ADDENDUM NO. 3

DATED: November 14, 2024

PROJECT:	WSD New Sr. High School	**DATE:**	11/14/2024
OWNER:	Wynne School District	**PROJECT NO:**	A-23010
TO:	Gary Hoyt Nabholz Construction	**CONTRACT FOR**:	General Construction

SHEET NUMBER
C2.05

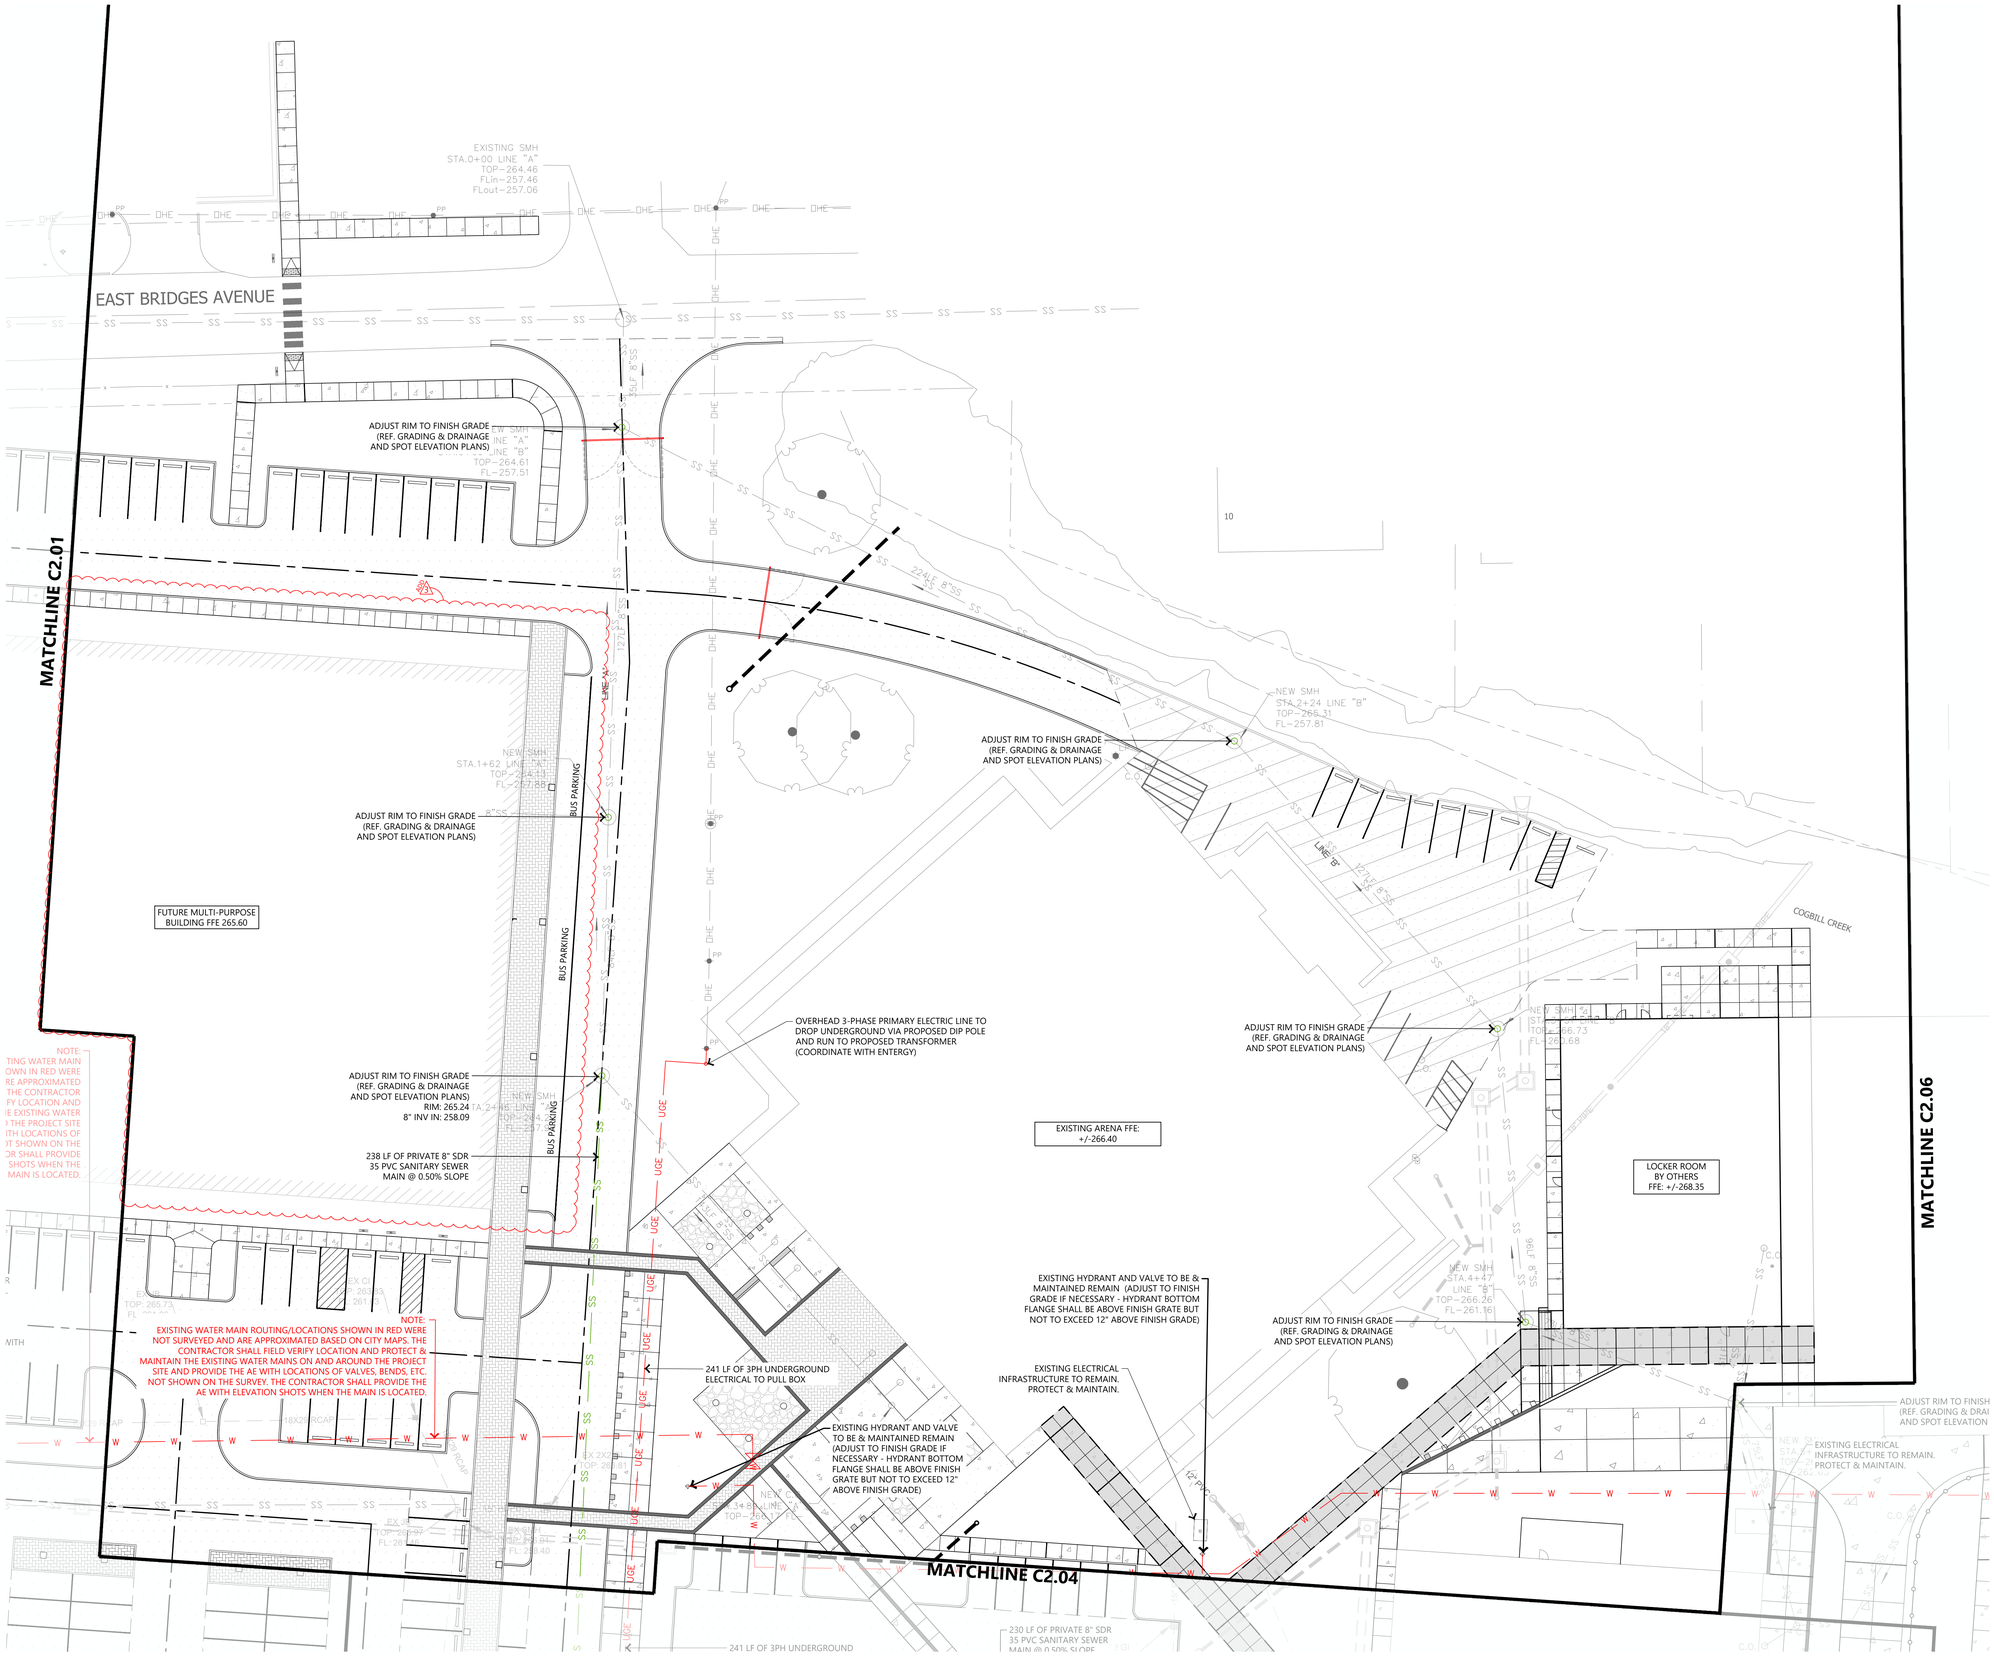
10. Sheet C2.01 UTILITY PLAN: Drawing has been updated and revised as indicated on drawing sheet.
11. Sheet C2.05 UTILITY PLAN: Drawing has been updated and revised as indicated on drawing sheet.

SHEET NUMBER
C3.00

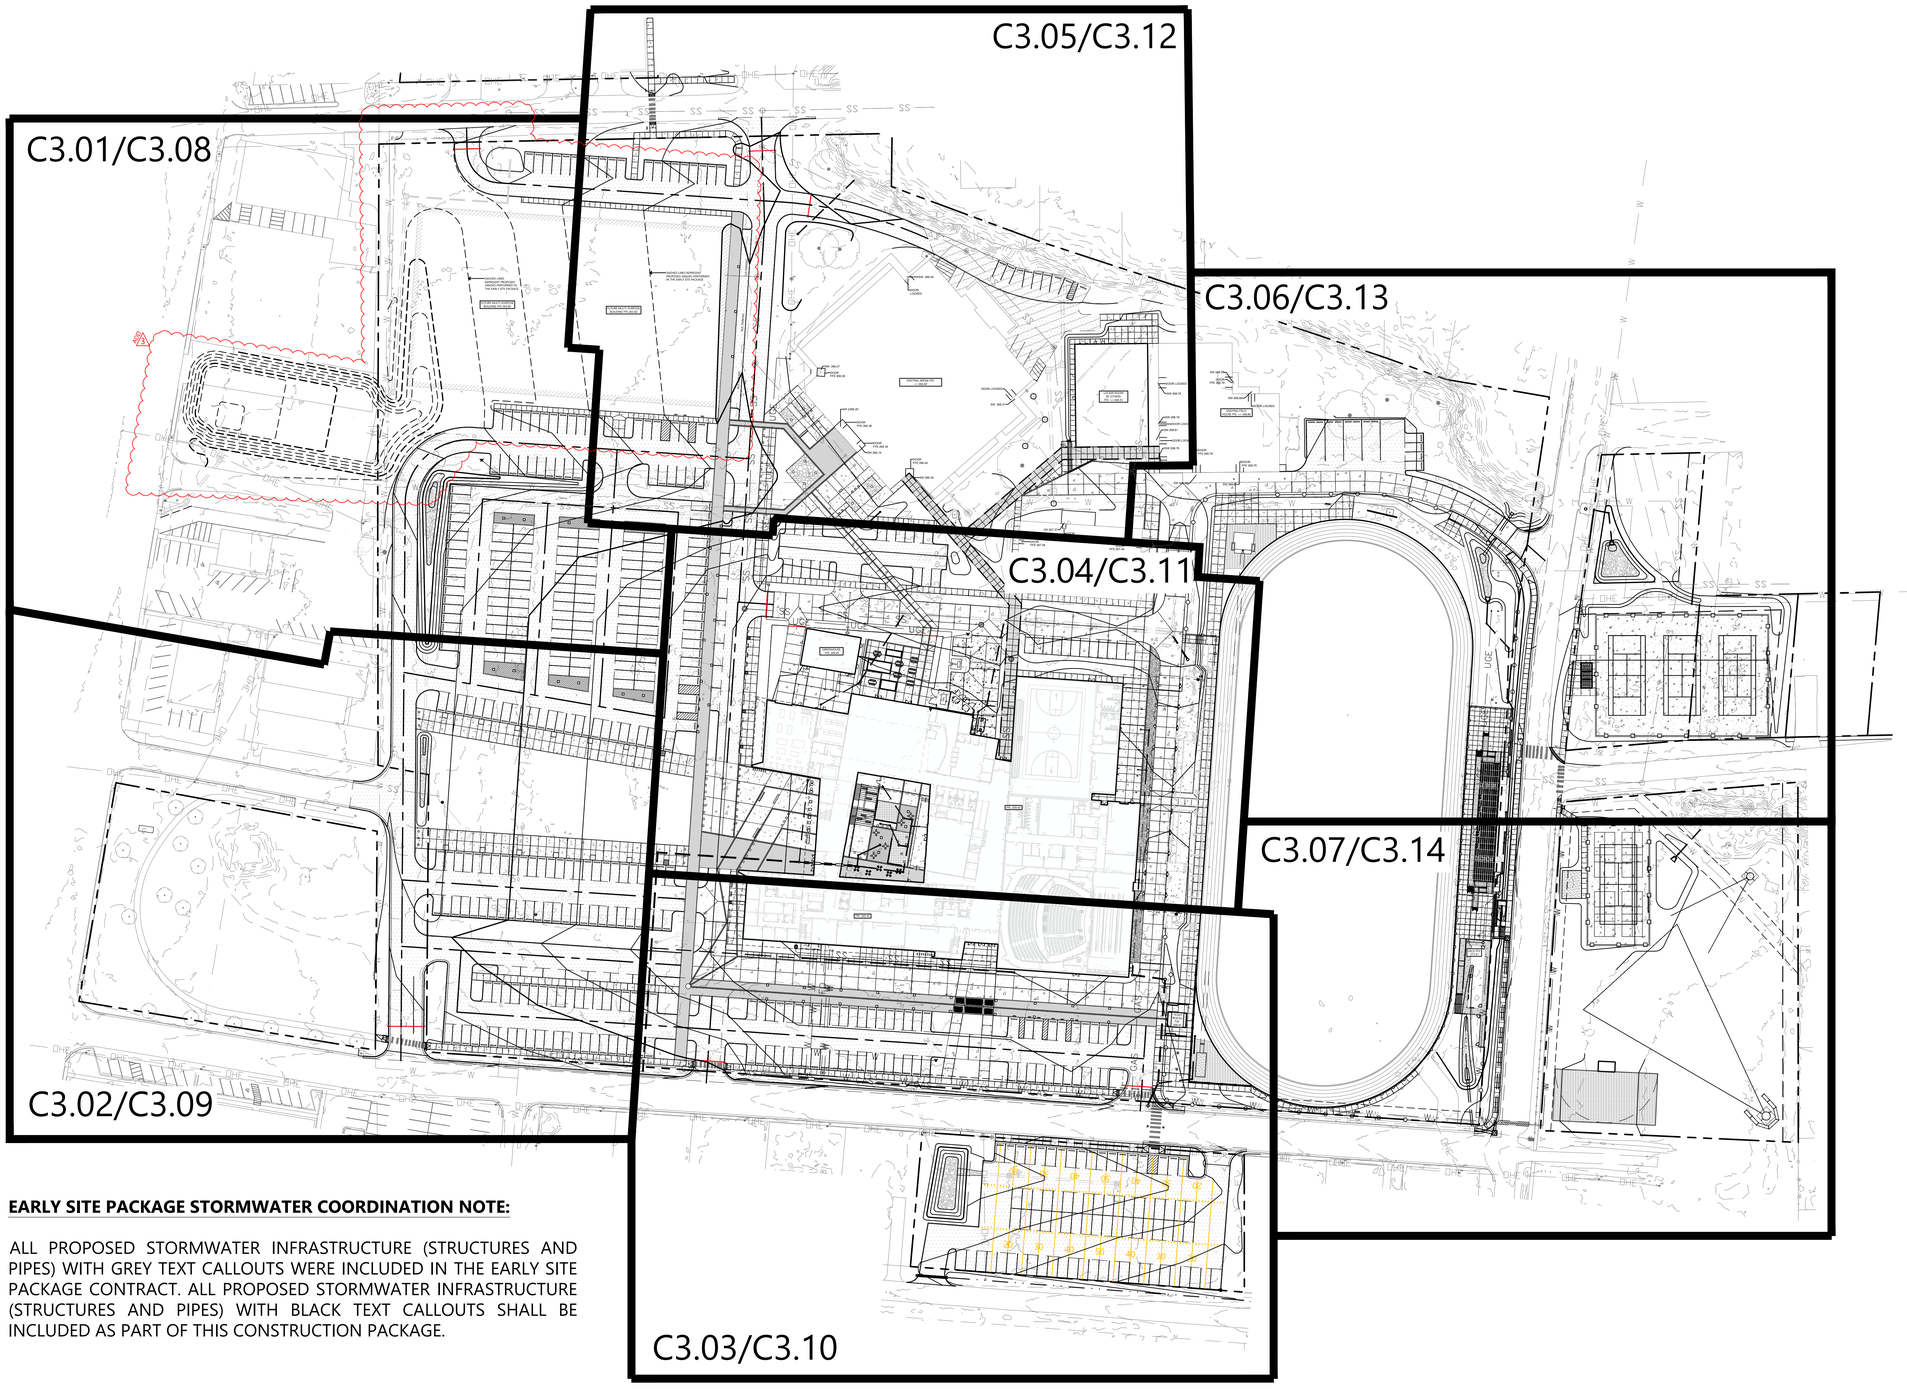
12. Sheet C3.00 OVERALL GRADING AND DRAINAGE PLAN: Drawing has been updated and revised as indicated on drawing sheet.
13. Sheet C3.01 GRADING AND DRAINAGE PLAN: Drawing has been updated and revised as indicated on drawing sheet.

SHEET NUMBER
C3.08

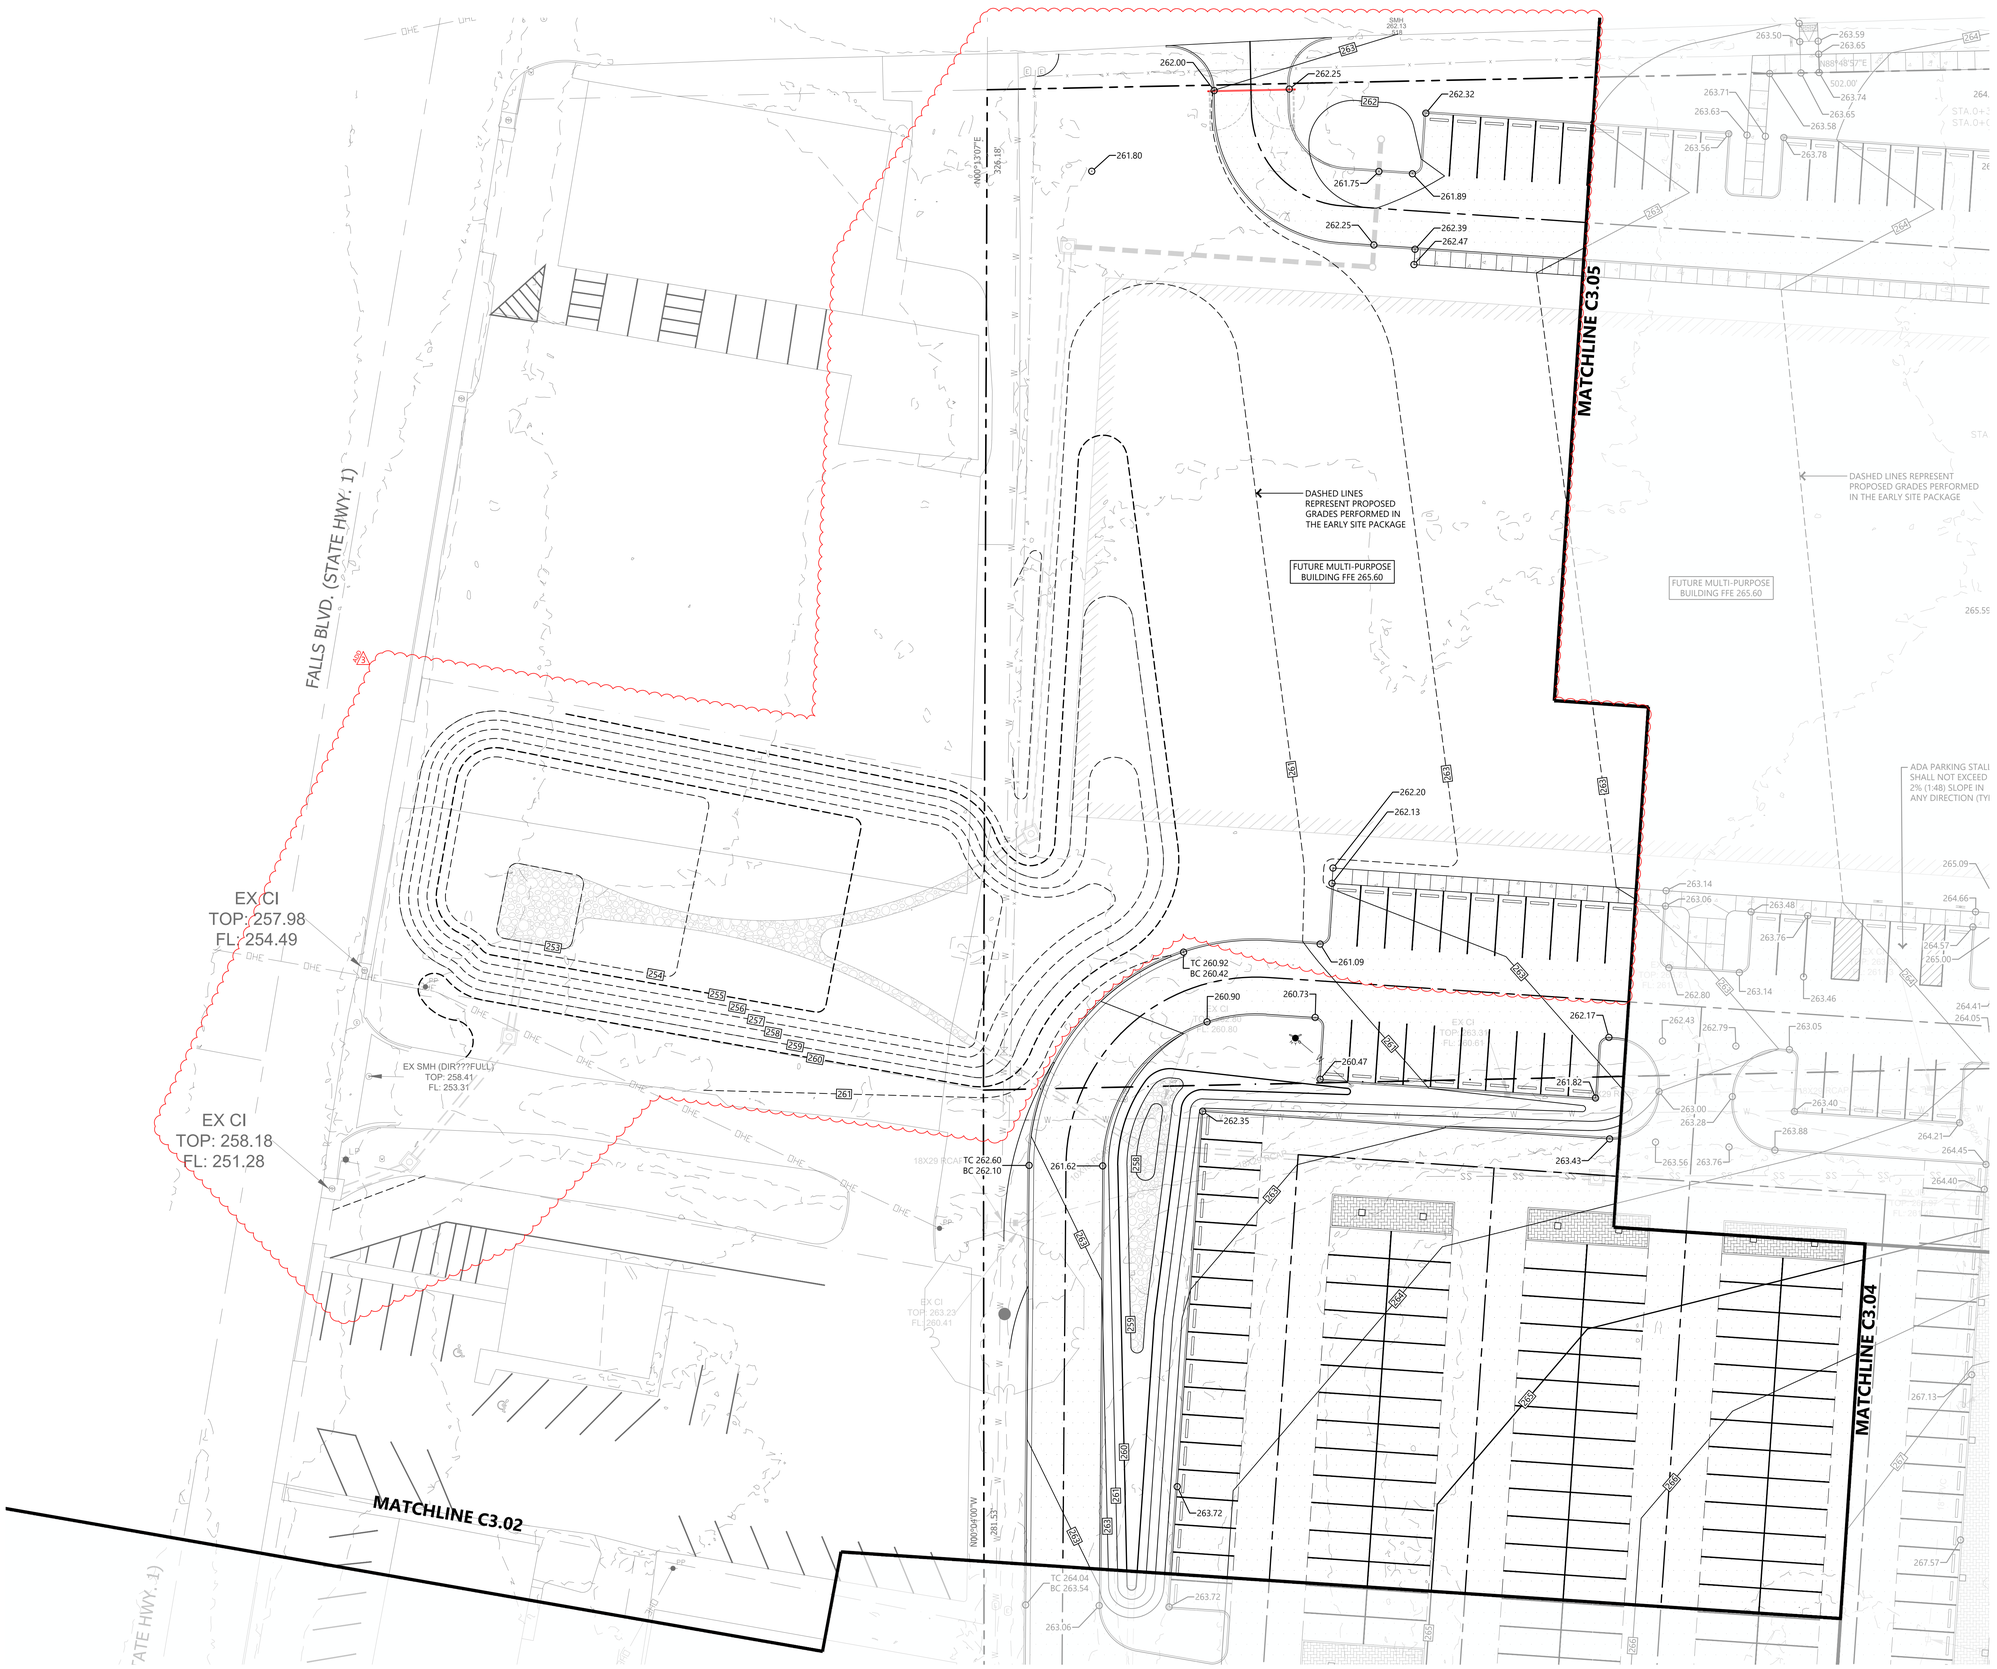
14. Sheet C3.05 GRADING AND DRAINAGE PLAN: Drawing has been updated and revised as indicated on drawing sheet.
15. Sheet C3.08 SPOT ELEVATION PLAN: Drawing has been updated and revised as indicated on drawing sheet.
